## Technical Service Bulletin (TSB)

### Flash: Electric Power Steering (EPS) Module Updates

| REFERENCE:         | TSB: 08-149-23 REV. A<br>GROUP 08 - Electrical                                                                                                                                                                                                                                                                                                                                                                                                                                                                                                                                                                                                                                              | Date: | June 23, 2023 | REVISION:                                                                                                                                                                                                           | 08-149-23 |
| VEHICLES AFFECTED: | 2023 (GC) Alfa Romeo Tonale<br>This bulletin applies to vehicles built on or before May 30, 2023 (MDH 0530XX).

**Fig. 1**  
**Example of wiTECH Step Flashes**

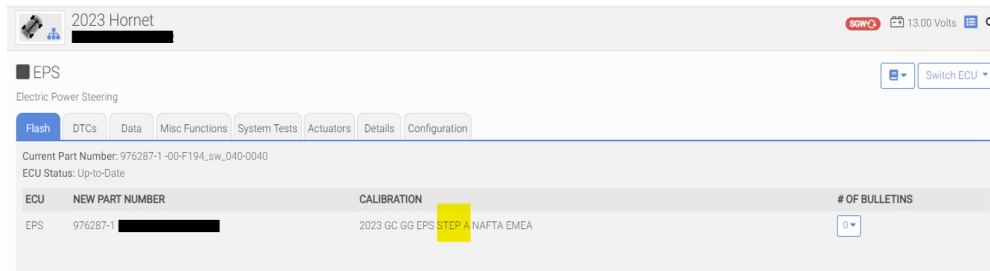
**CAUTION! \*\*Multiple step flashes up to three may be necessary and are required to completely update this EPS these must be performed in order starting with STEP A or B and ending with Step C, be sure to follow wiTECH accordingly (Fig. 1) .\*\***

3. **\*\*Select the appropriate software per wiTECH (Step A, B or C) either Step A or B must be done first in order and end with Step C when finished.\*\***
4. Reprogram the EPS module with the latest software. Detailed instructions for flashing control modules using the wiTECH Diagnostic Application are available by selecting the application's "HELP" tab.
5. Wait 2 minutes after the EPS flash has been completed.
6. To perform an EPS reset with wiTECH - Go to the Guided Diagnostics menu --> Select Reset ECU --> Select "EPS" from the list of modules --> Click "Continue" at the bottom of the page then follow the wiTECH prompts.
